Re: **Initial Submission Review** – High Point at DIA – FDP Amendment with Waiver, Comprehensive Plan Amendment and Rezone
 Application Number: DA-1746-19
 Case Numbers: 2004-7002-04; 2019-1001-00; 2004-2017-01

Initial Submission Review

**Re: High Point at DIA Rezone, Comprehensive Plan Amd and Framework
Development Plan Amd with Waiver – Case # DA-1746-19**

Figure F-1

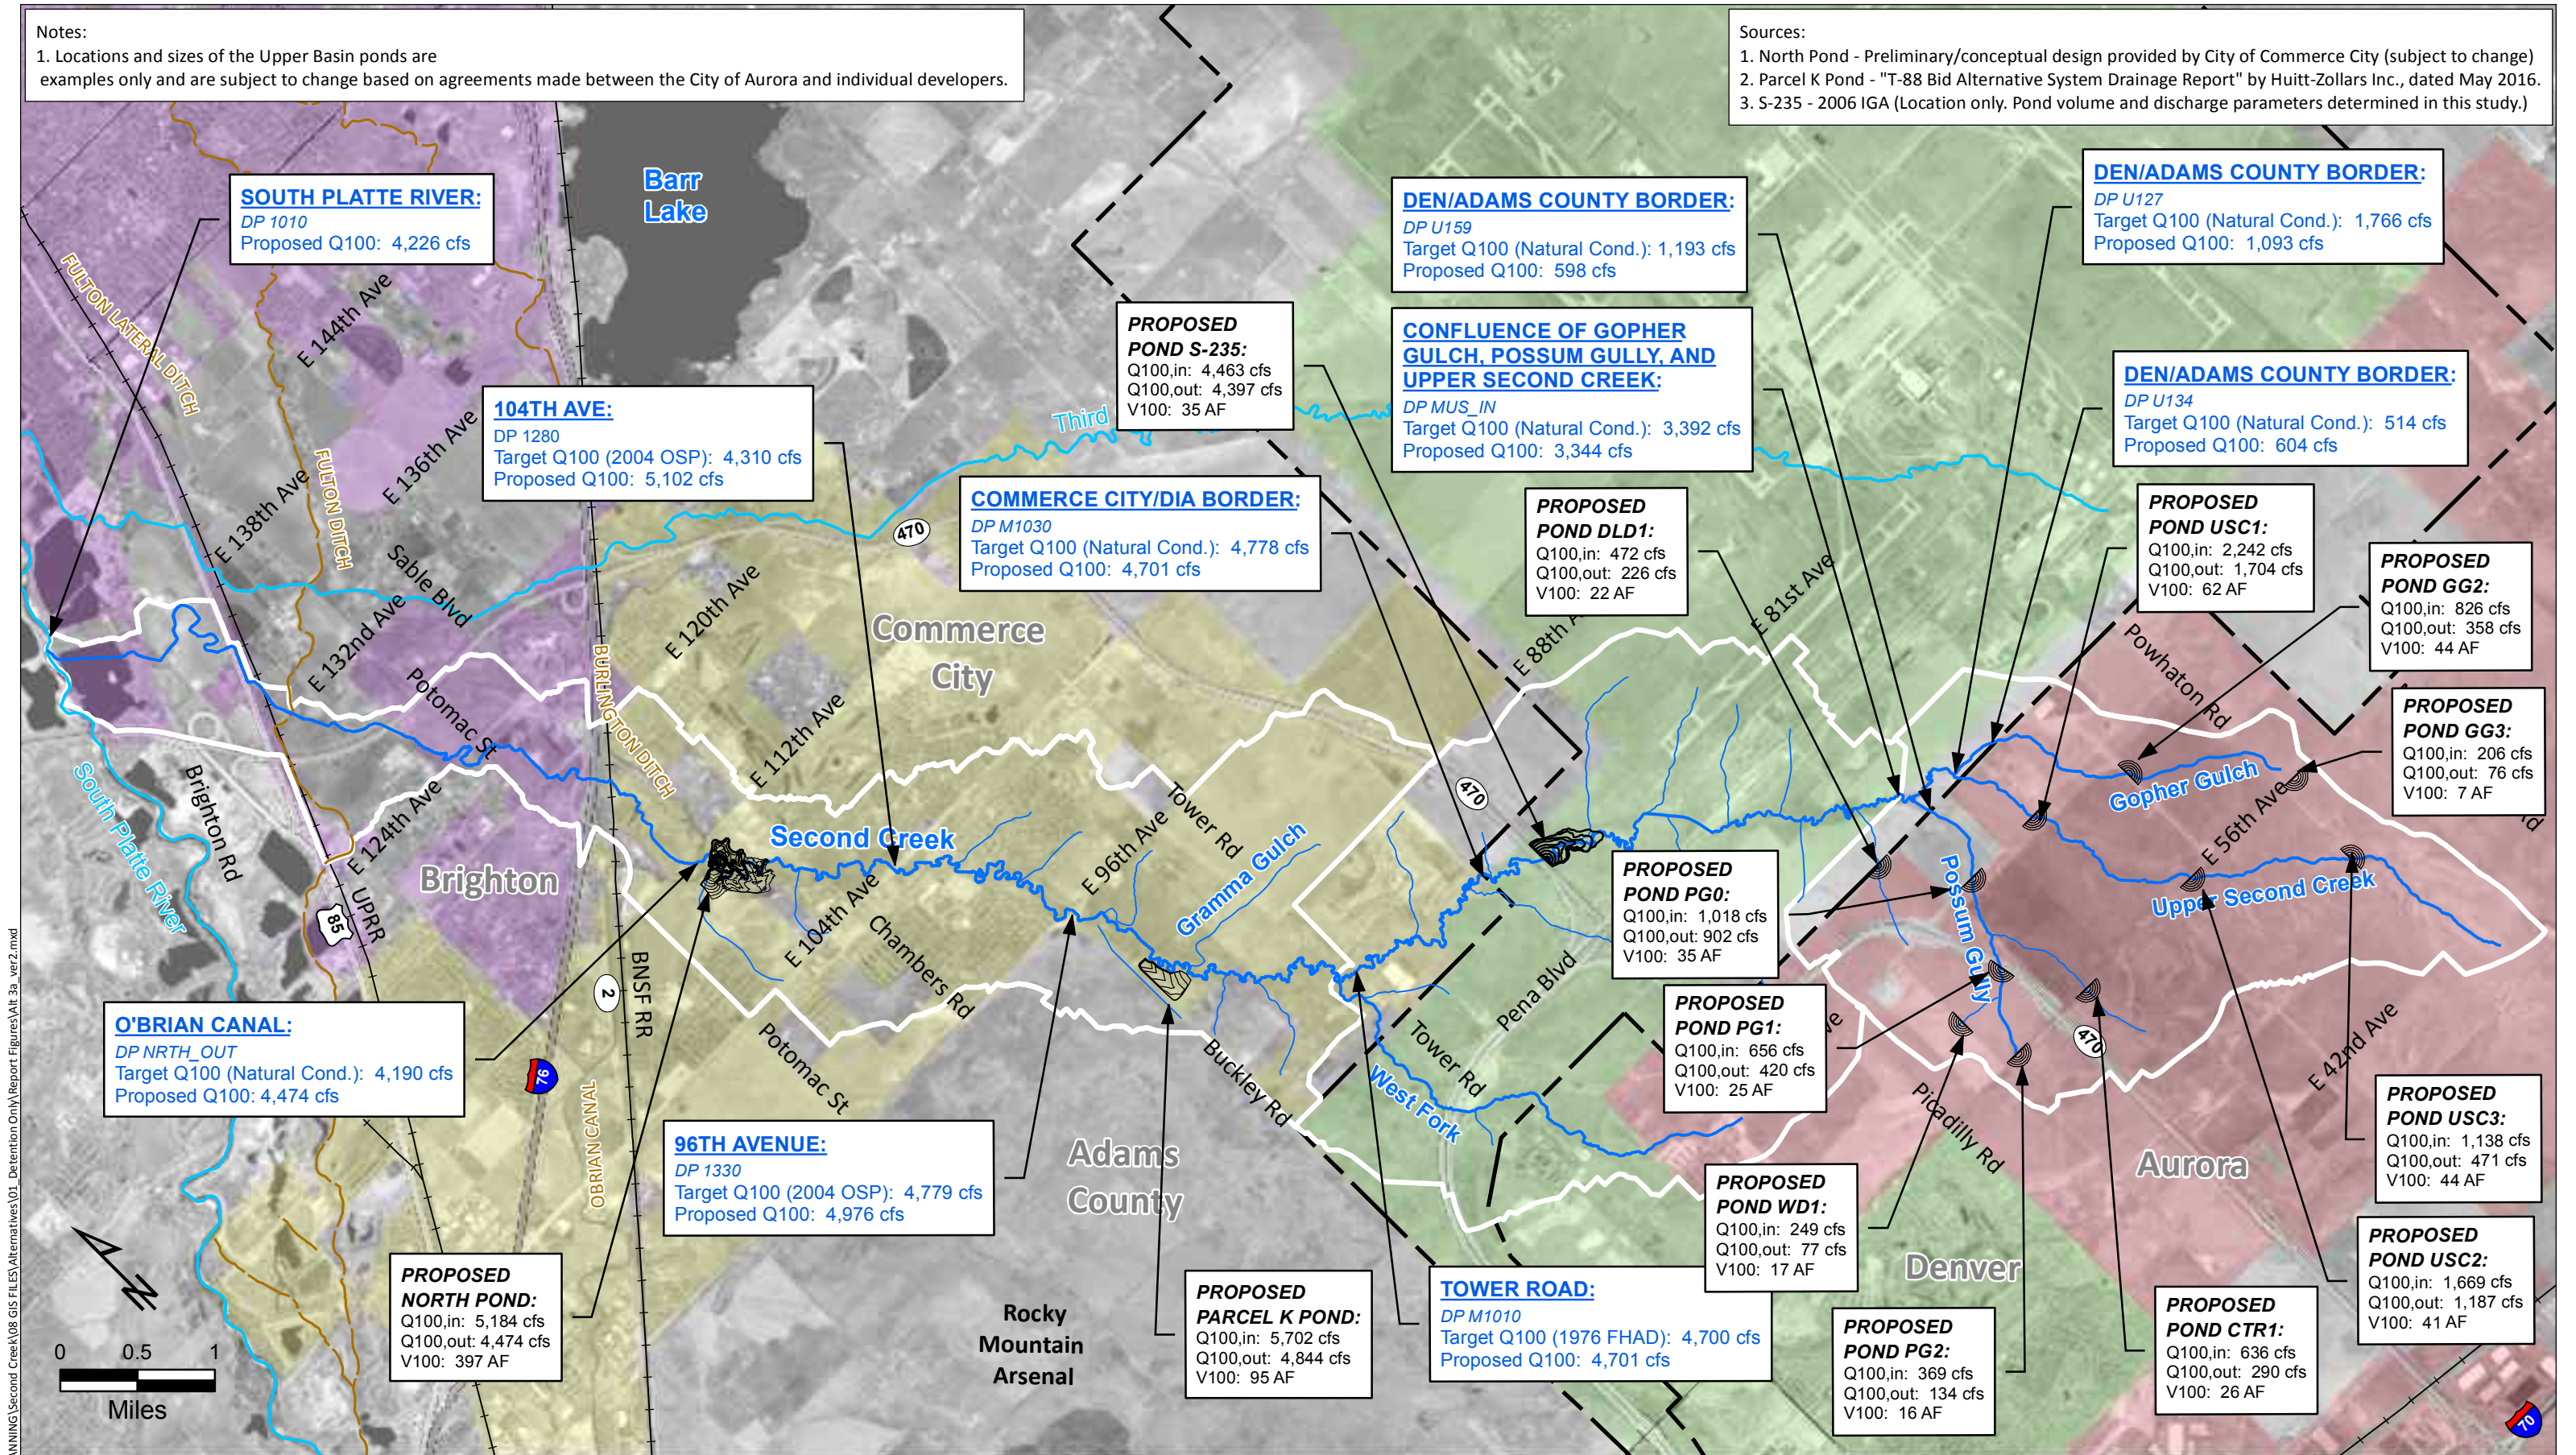
1. There is an ongoing master plan for the Second Creek watershed, and although the local governments haven't officially selected an alternative from the master plan, the recommended alternative 3A shows regional detention basins on Dandelion Draw and on Possum Gully within this development. All indications are that this will be the detention scenario that we move forward with, which means this development must plan to build these facilities as shown on the master plan.

2. I've provided an excerpt from the Second Creek master plan showing the location of the proposed detention basins. The intent of the master plan is to:

- b. Evenly distribute regional detention basins amongst the various developments planned for the upstream watershed to achieve the aforementioned flow reduction. All of the detention basin locations and sizes have been situated to achieve this goal, meaning detention throughout the entire system upstream of DIA must work together. Planned regional detention basins can't be moved around or resized without confirming that the entire system still functions as intended.
